ALERT SERVICE BULLETIN

SUBJECT: MAIN ROTOR DRIVE - MGB emergency spraying system

Increase in the reliability of the EMLUB system by addition of a relay
 Corresponds to modification 0728369

Revision No.	Date of issue
Revision 0	2016-08-31
Revision 1	2016-10-07

Figure 4: Ground 686VN

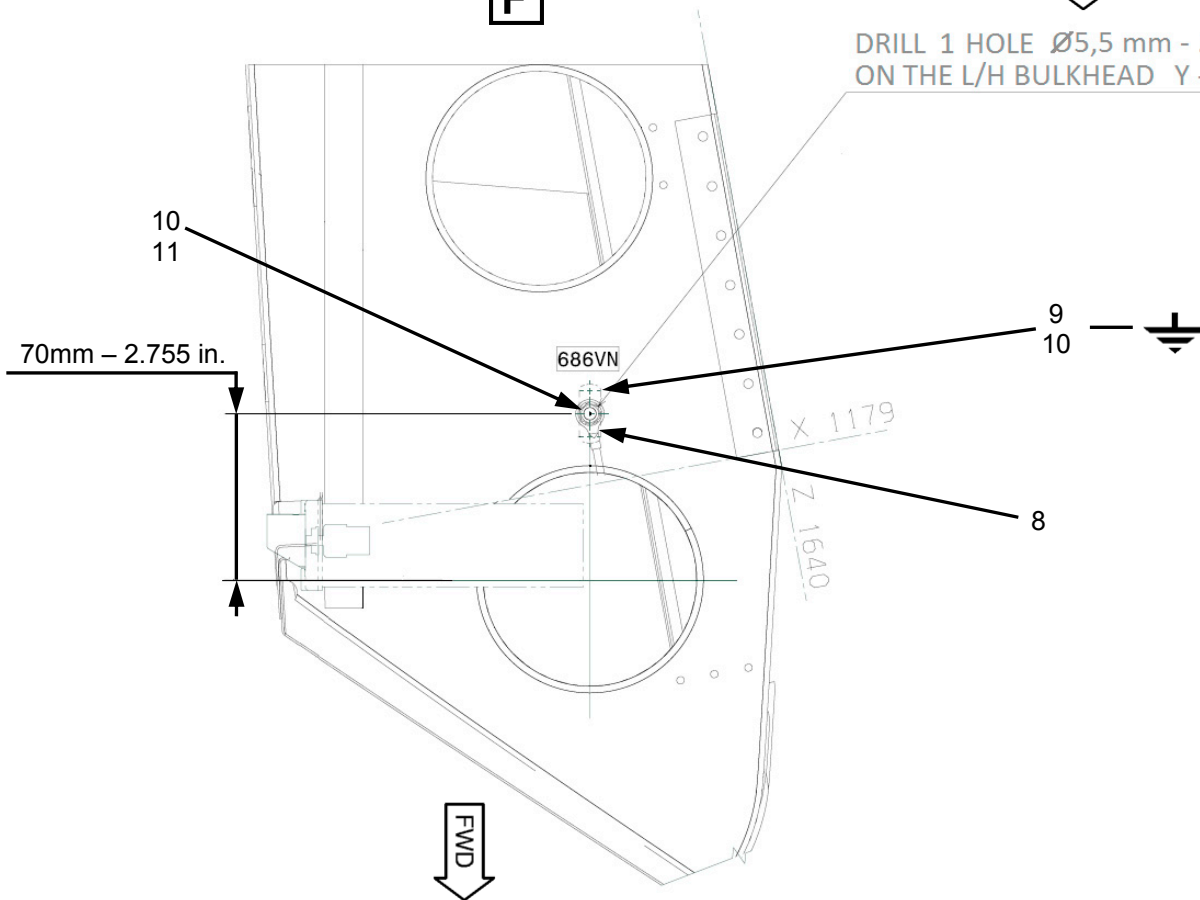
3.B.2.b. Installation of ground point "686VN" (Figure 4)

- Install ground point "686VN" (Figure 4)
 - . Obey dimensions of Detail F, Figure 4:
 - .. Drill and deburr holes as per detail A.
 - .. Do the electrical bonding as per Detail A and as per MTC Work Card 20.02.07.401.
 - .. Install self-locking nut (9) using blind rivets (10).
